*Department of Transportation
and Public Facilities*

TITLE: Handicapped Access on Ferries

SUBJECT: Project #304033
F-9500(13), M/V
LeCONTE Galley
and Finishing Mod.

SUBJECT: M/V LeCONTE Galley & Finishings Modifications

SITE #1

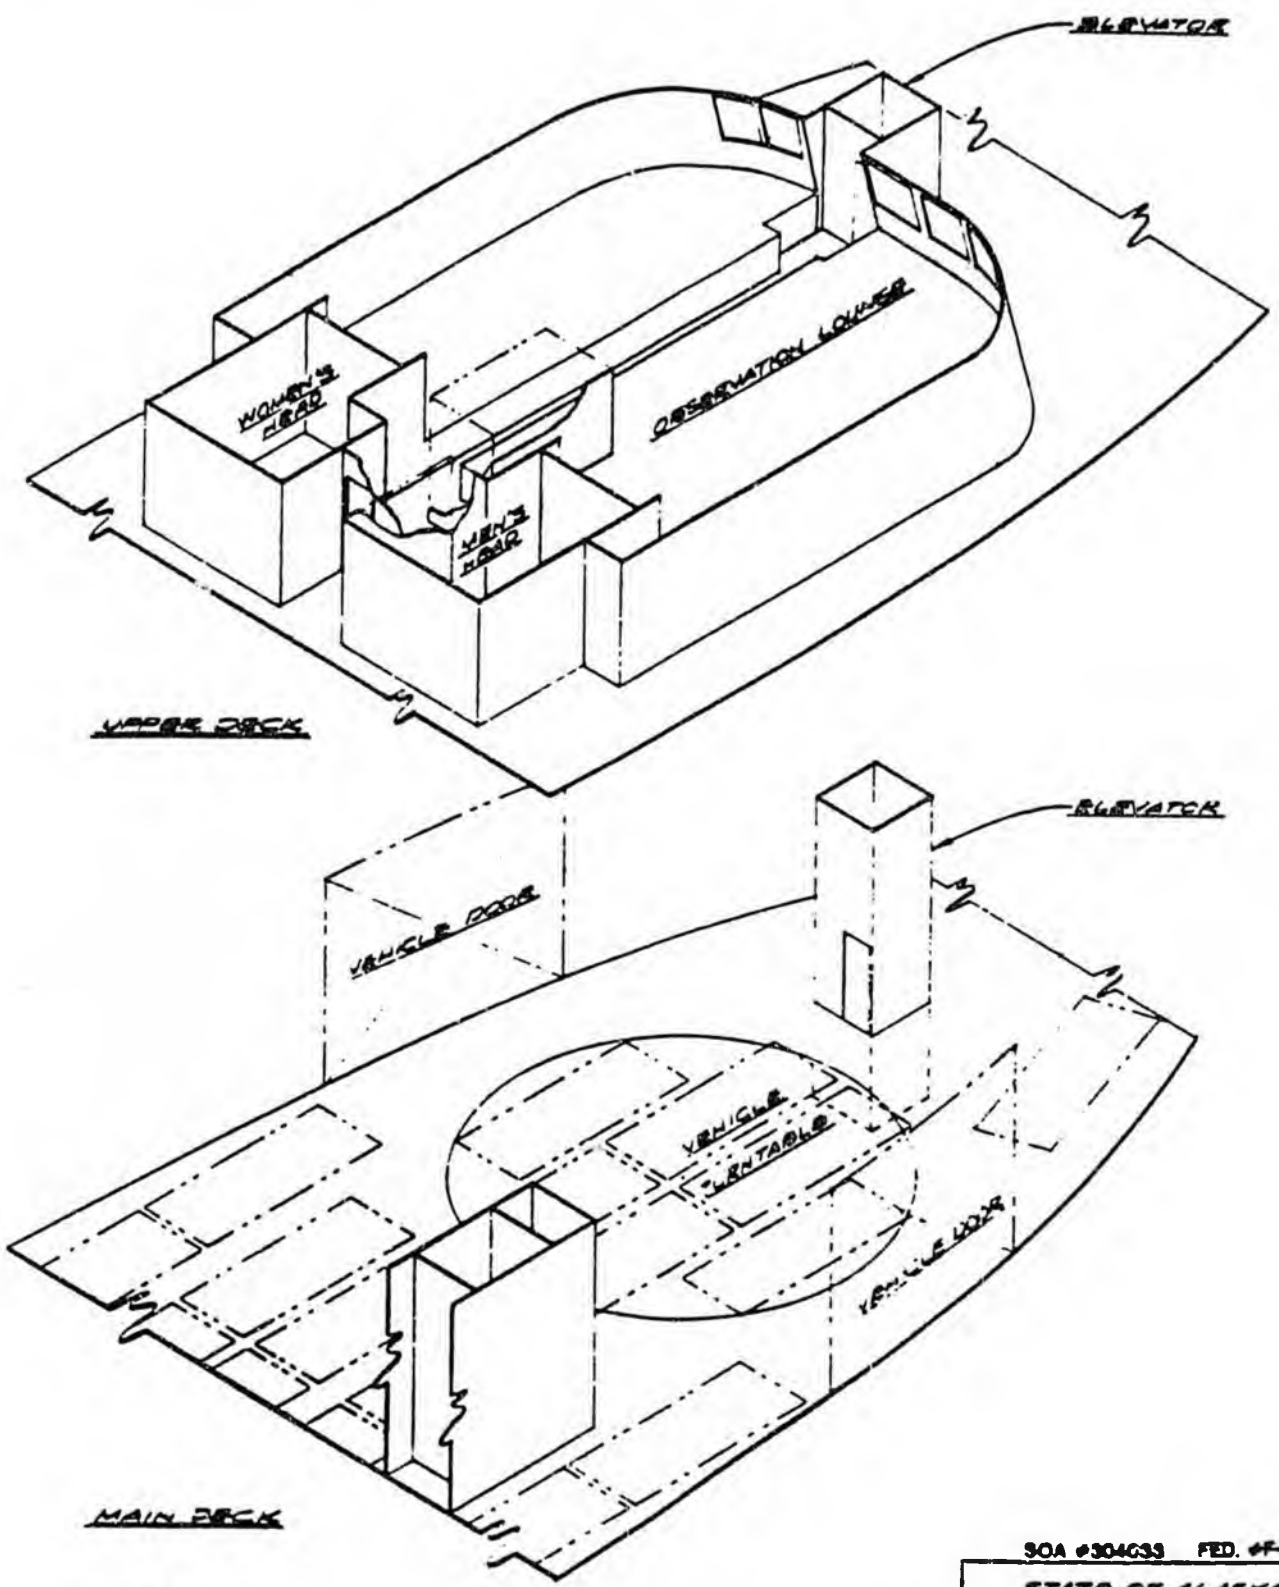
The forward end of the recessed walkway should be better defined. If wheelchair turnaround is necessary, then the width of the notch should be confirmed. If possible, the notch should be eliminated.

SITE #2

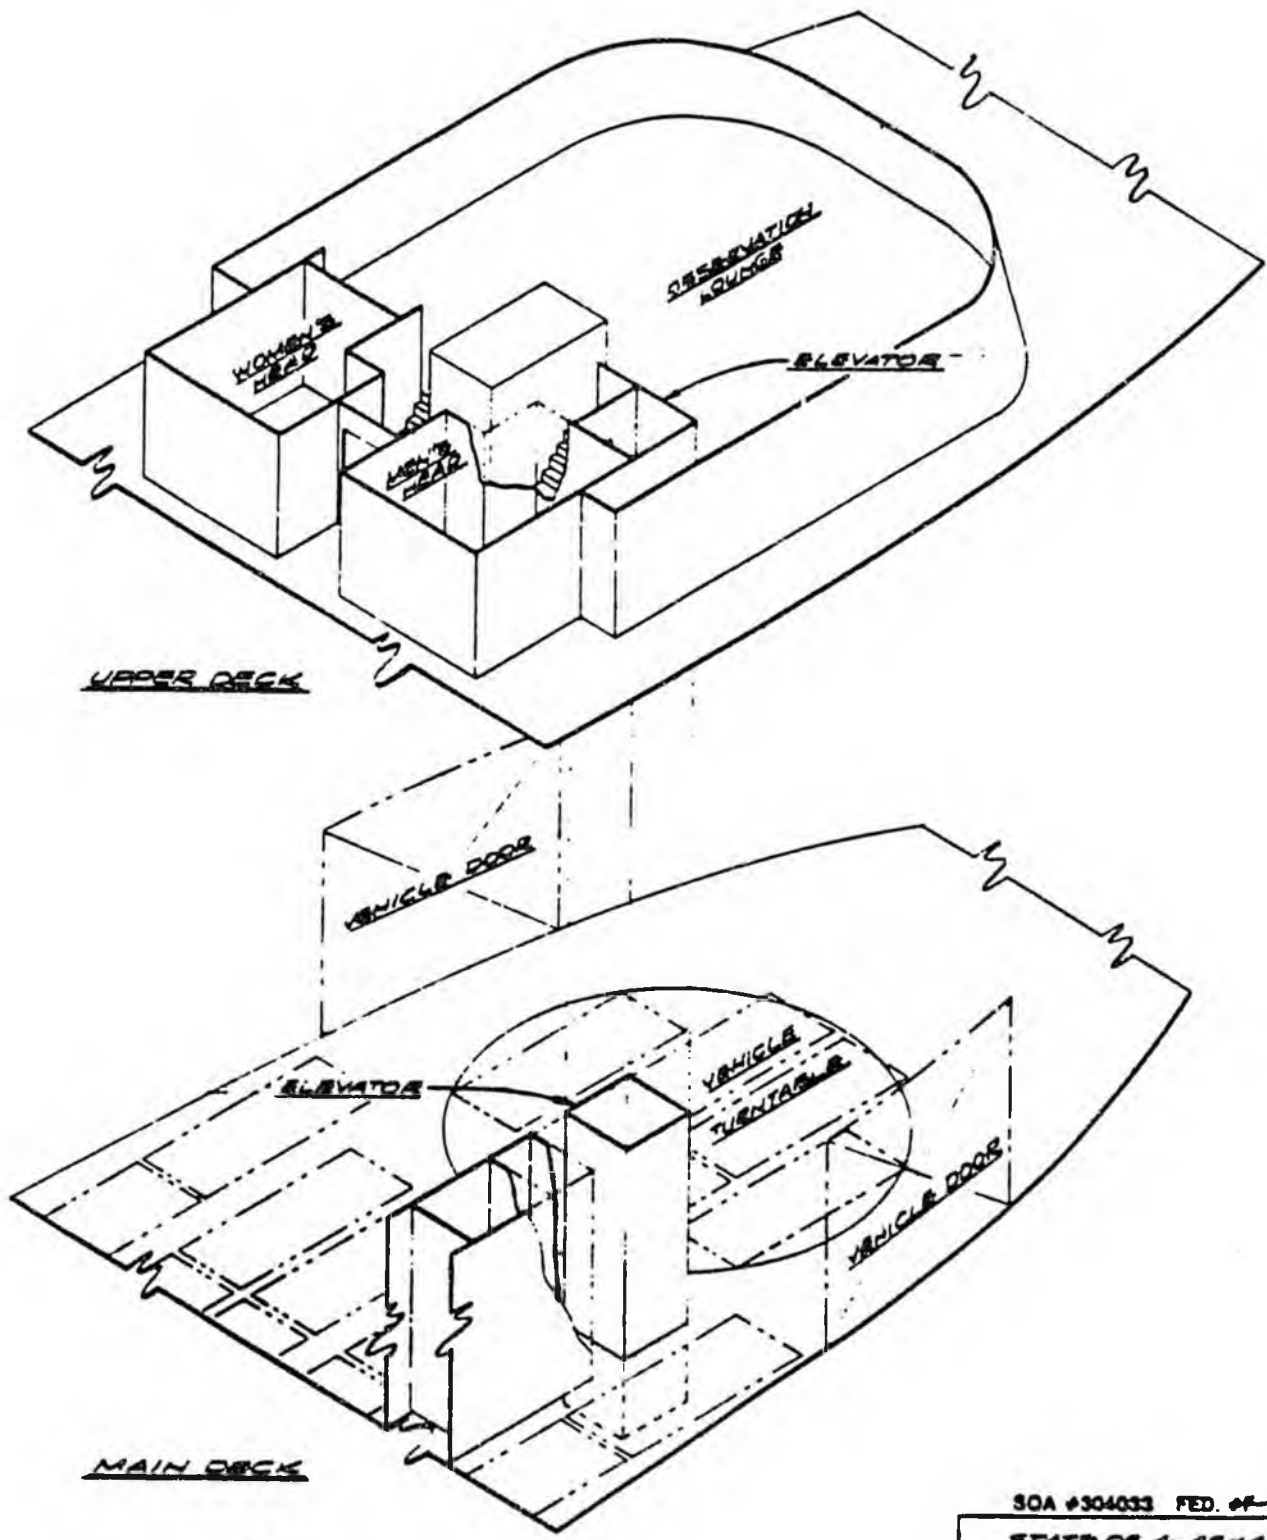
During the period 1/9/87 through 1/23/87, a hoistway obstruction was placed on the main (car) deck in way of the proposed elevator site (#2 - Glosten Concept, dated 11/20/86).

I visited the vessel on each arrival in Auke Bay (1/9, 1/11, 1/16, 1/18 and 1/23) specifically to witness loading operations. In each instance, several attempts were required to situate vehicles (31' to 40' excluding the tractor unit). It must be pointed out that the main deck in all cases was devoid of other vehicles, which afforded ample room to maneuver these units. However, this luxury normally would be precluded during peak traffic months by through traffic.

Discussions with the Chief Mate indicate that occasions arise that require using the turntable to load "booked" traffic in excess of twenty-eight feet (28'). The turntable will not function unless the applied weight is evenly distributed which causes a one to two foot (1' to 2') overhang of the vehicle being loaded with the turntable (turntable diameter is 32'). The elevator hoistway location is within eight inches (8") of the turntable perimeter. It appears that the turntable, depending on traffic, will be unusable.

The installed hoistway will eliminate the turning radius currently available and required to clear the transfer bridge when loading standard size vehicles in the "tunnel". The "tunnel" is presently loaded aft to forward by backing vehicles in. The hoistway location also reduces the effective "tunnel" width from eight to six feet (8' to 6') at the forward end. A standard vehicle is approximately six feet (6') in width excluding any

appurtenances (mirrors, etc.). The "tunnel" will be restricted to compacts and sub-compacts only unless through traffic is off-loaded to gain access to and from the after end for standard size vehicles. A portable ramp will be necessary to negotiate the height obstacle of the transfer bridge at the forward end of the "tunnel".

While it appears that the vessel can accommodate units larger than twenty-eight feet (28') in length, the actual capability cannot be documented under the conditions encountered. Furthermore, accessibility to and from the "tunnel" will be severely reduced.

I would suggest that this portion of the subject project be deferred until such time as the elevator installation can be accommodated in such a way as to not interfere with the vessel's present capabilities.

SITE #3

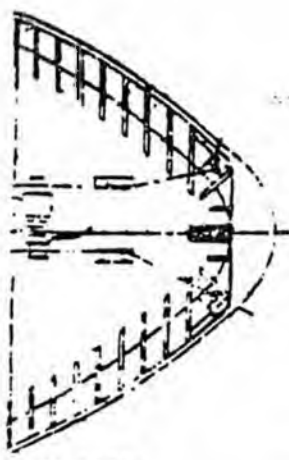
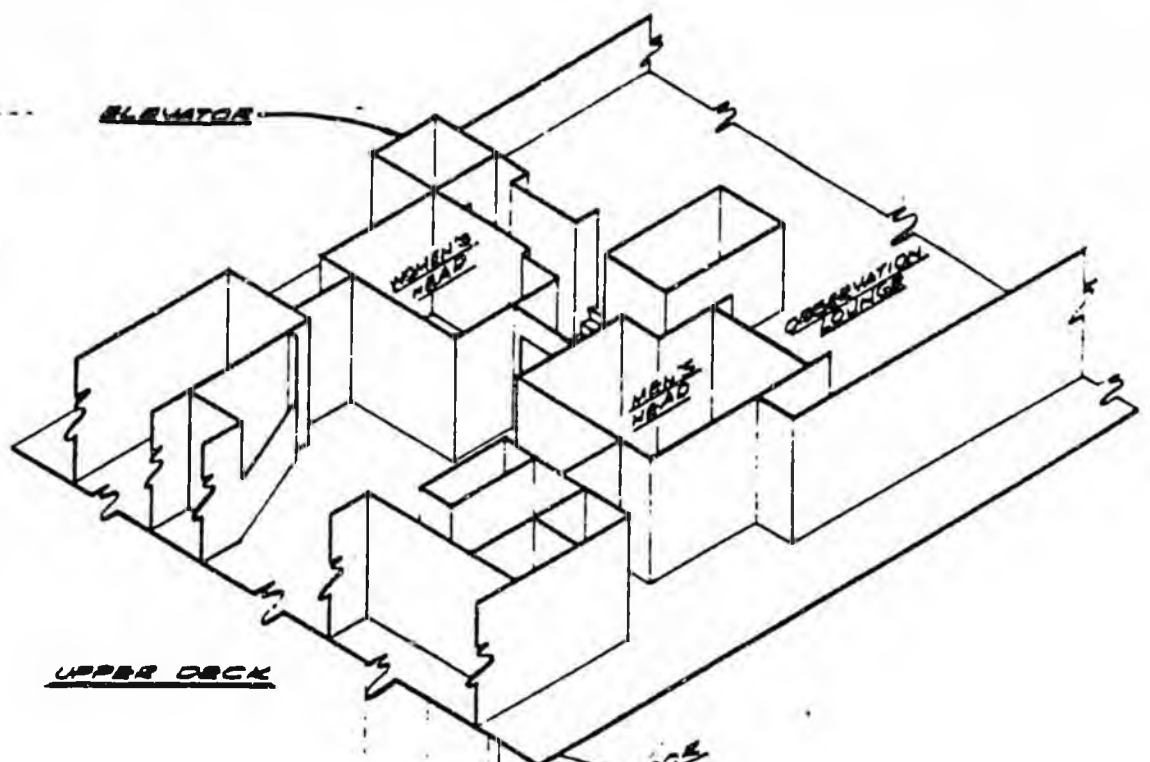
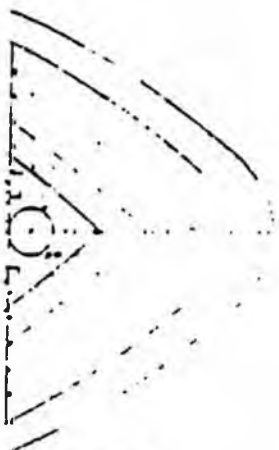
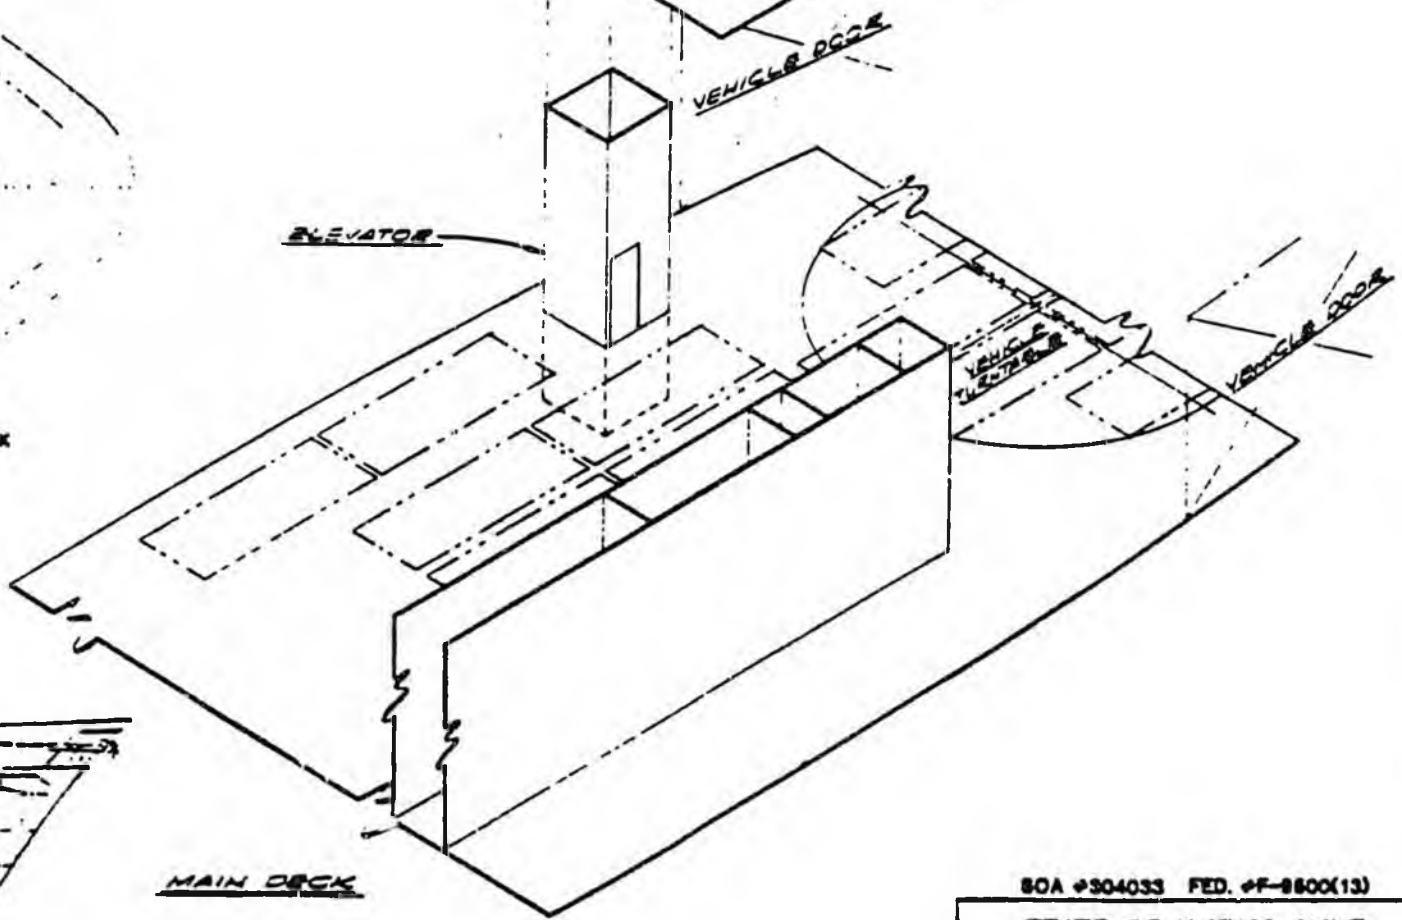
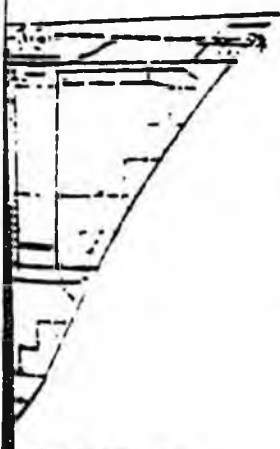
A new access door to the outside may be necessary, aft in the observation lounge on the port side.

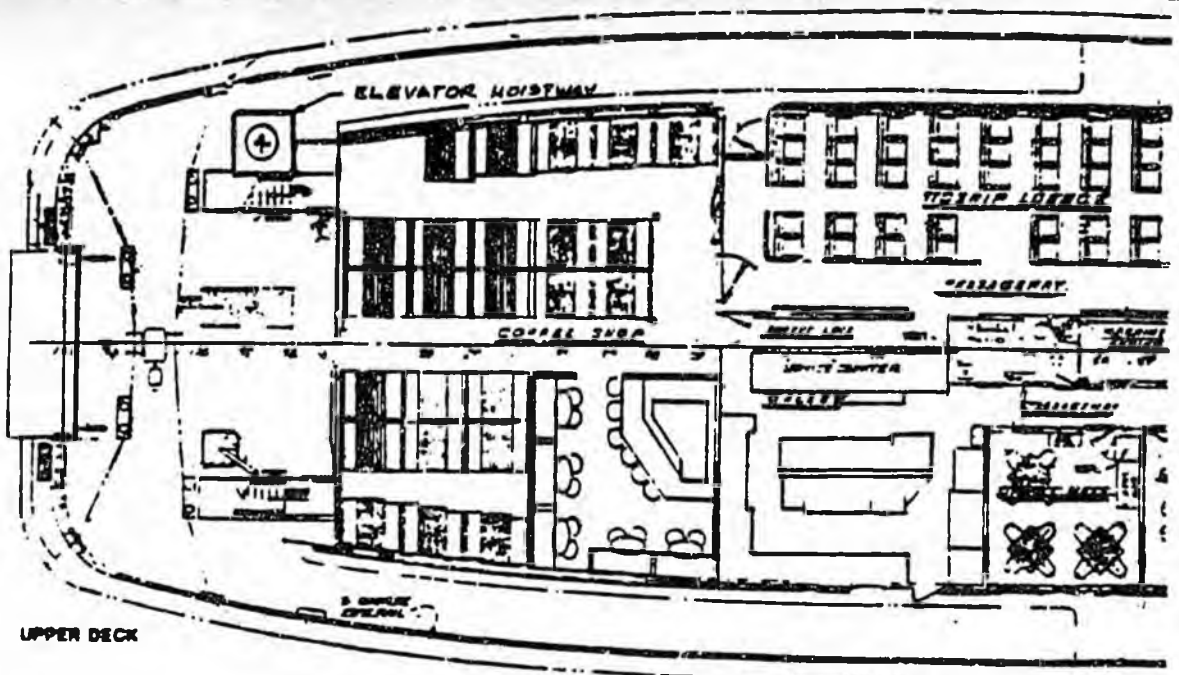
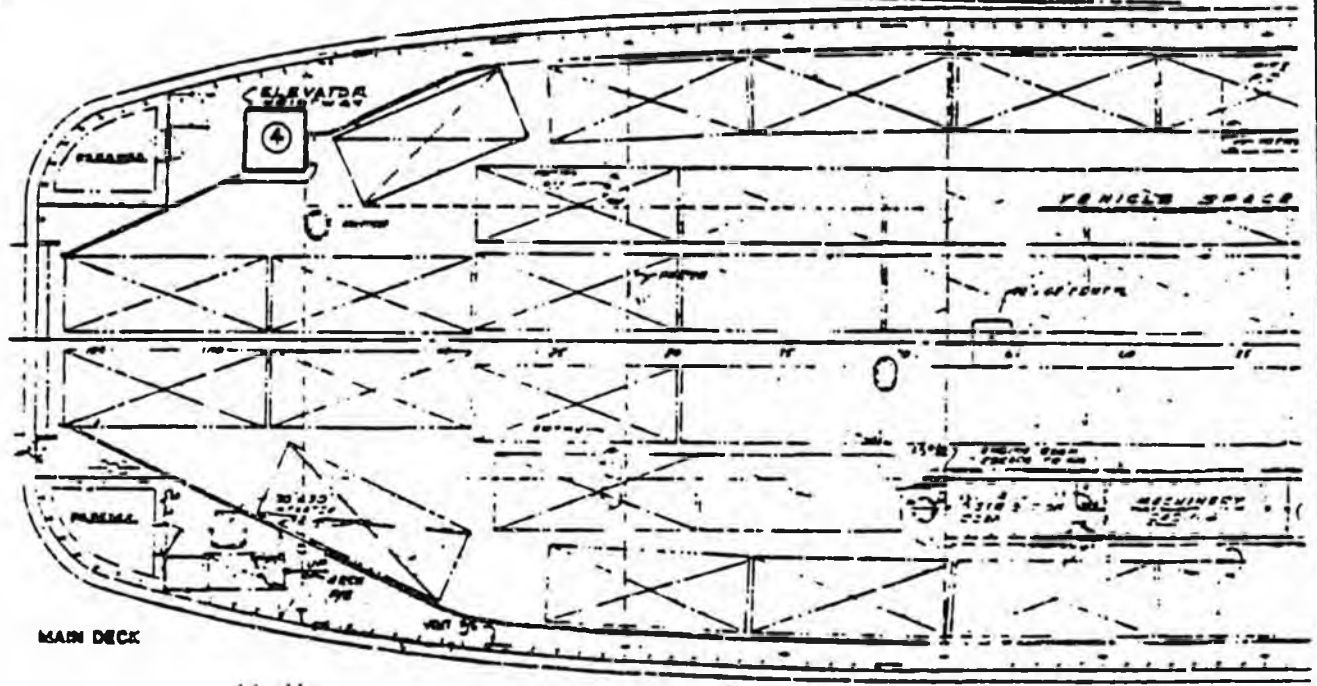
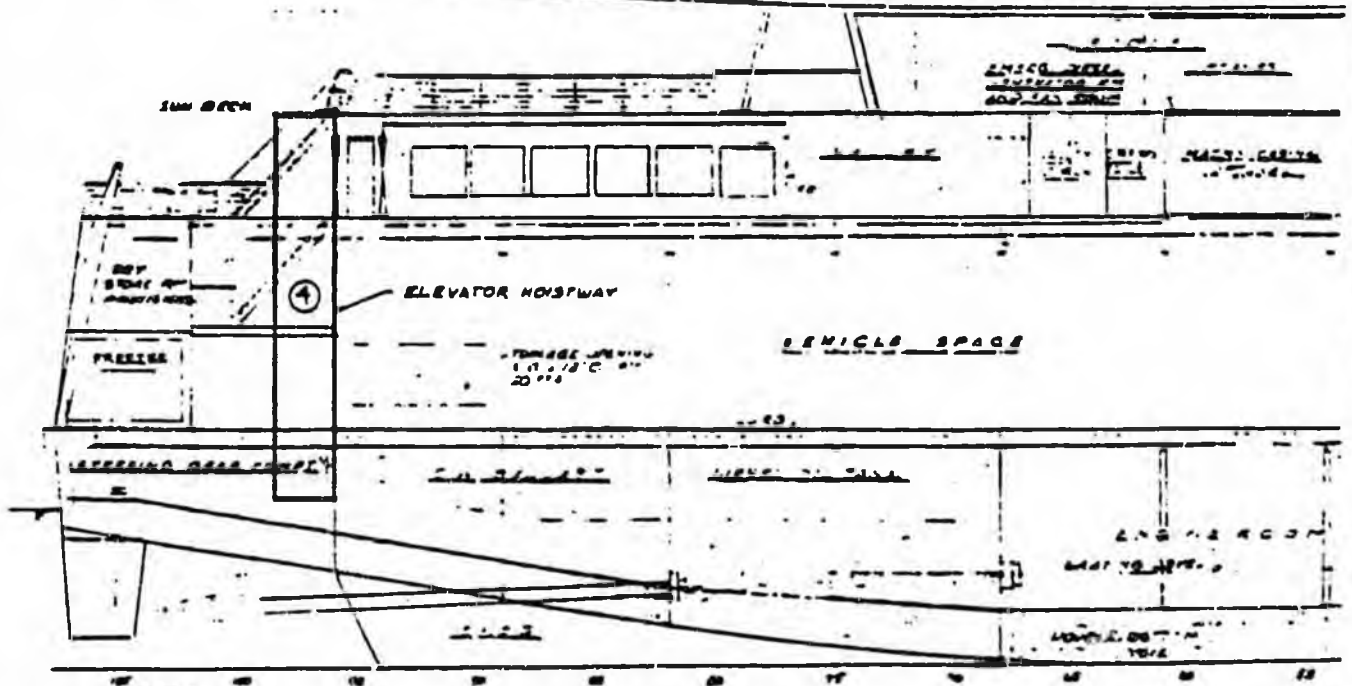
It is important to note that while the general arrangement plans show a 3 foot space between cars, vans and campers are often carried which are wider and reduce this space to one foot. So in reality, maintaining this three foot wide path would surely reduce the available parking area.

Access to the gallery deck stores space should be worked out. A new ladder could be provided, if determined necessary.

If the central refrigeration system is included, and this option, the arrangement may change slightly.
